**SHEARON HARRIS NUCLEAR POWER PLANT, UNITS 2 AND 3  
DOCKET NOS. 52-022 AND 52-023  
SUPPLEMENT 1 TO RESPONSE TO REQUEST FOR ADDITIONAL INFORMATION LETTER  
NO. 052 RELATED TO RAW WATER SYSTEM**

**Shearon Harris Nuclear Power Plant Units 2 and 3  
Supplement 1 to Response to NRC Request for Additional Information Letter No. 052  
Related to SRP Section 09.02.01 for the Combined License Application,  
dated December 30, 2008**

**NRC RAI NUMBER:** 09.02.01-7

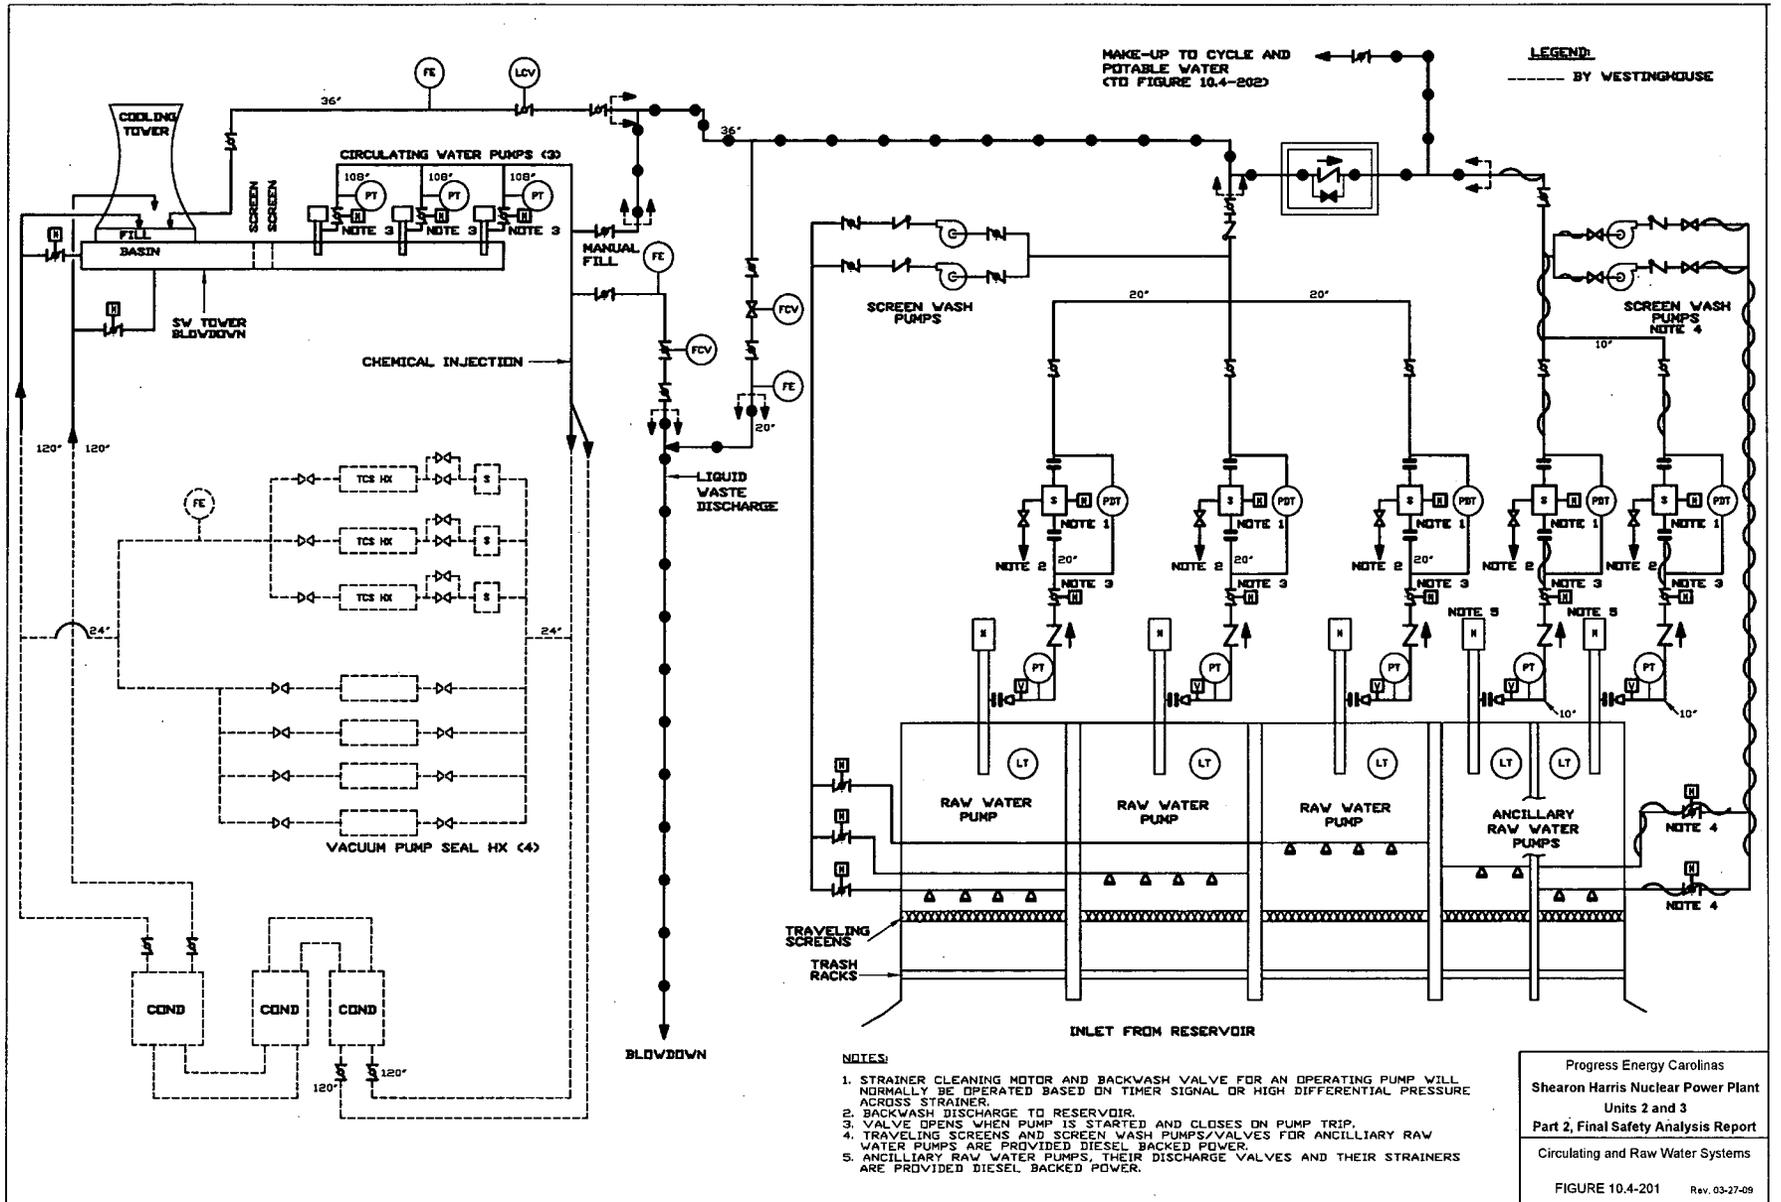
1. The check valve in the discharge header for the ancillary raw water pumps immediately downstream of the suction line for the screen wash pumps was eliminated;

These changes are reflected in revisions to FSAR Figures 10.4-201 and 10.4-202. None of these changes impact the text of the original response to the RAI; the only change is to substitute the revised FSAR figures enclosed with this supplemental letter for those provided in the February 13, 2009 letter.

1. Replace Figure 10.4-201, Revision 0, with Figure 10.4-201, Revision 03-27-09
2. Replace Figure 10.4-202, Revision 0, with Figure 10.4-202, Revision 03-27-09

Progress Energy Carolinas Shearon Harris Nuclear Power Plant Units 2 and 3 Part 2, Final Safety Analysis Report Raw Water Distribution System FIGURE 10.4-202 Rev. 03-27-09
--

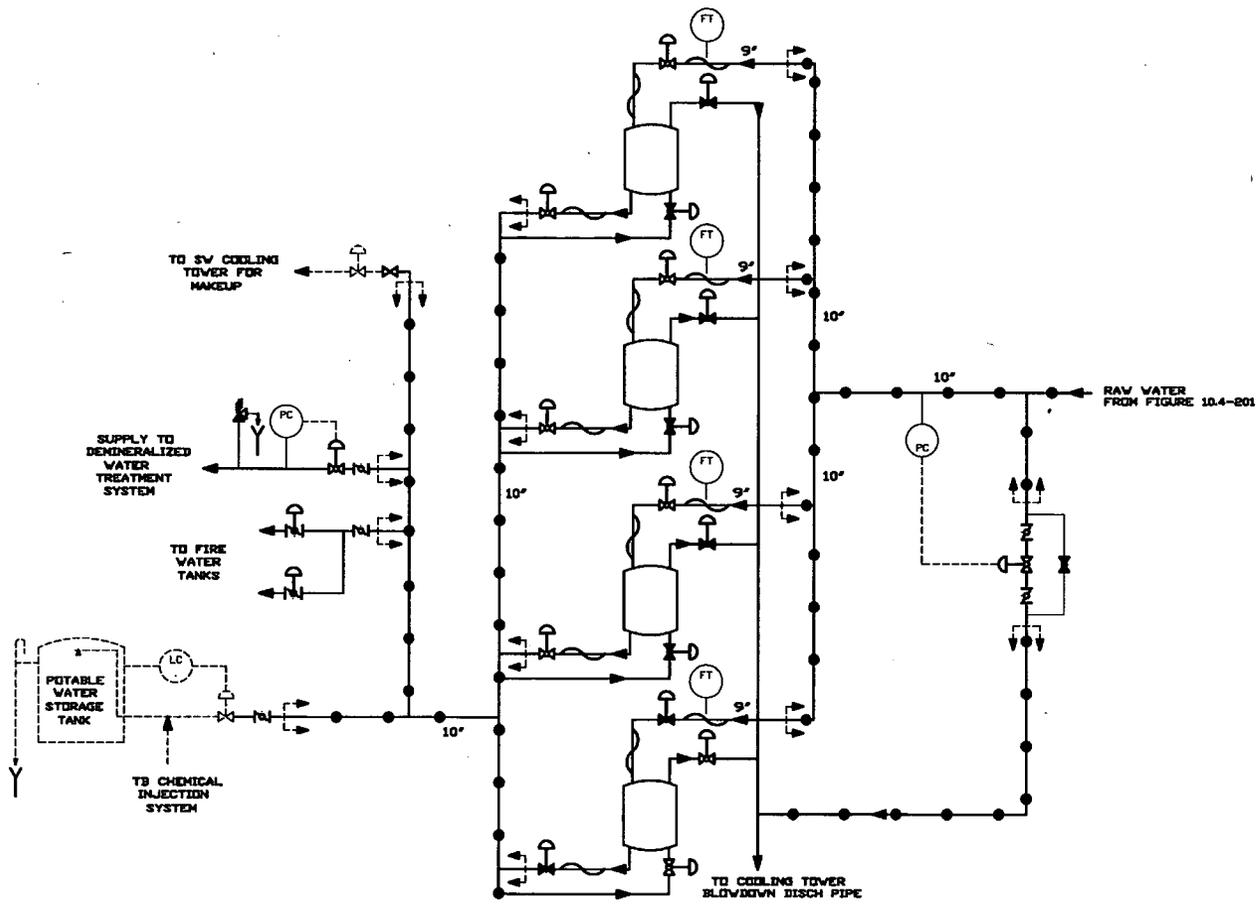
2. Normally-open manual isolation valves were added at the interface points with the four process systems downstream of the media filters (upstream of the potable water system, upstream of the fire water storage tanks, upstream of the demineralized water treatment system, and upstream of the service water system); and

3. The automatic recirculation valve upstream of the media filters was eliminated. A new control valve was added to the recirculation line upstream of the media filters along with a pressure control system to control its operation. In addition, normally-open manual isolation valves were added immediately upstream and downstream of the new control valve and a normally-closed bypass valve was provided around the control valve station.
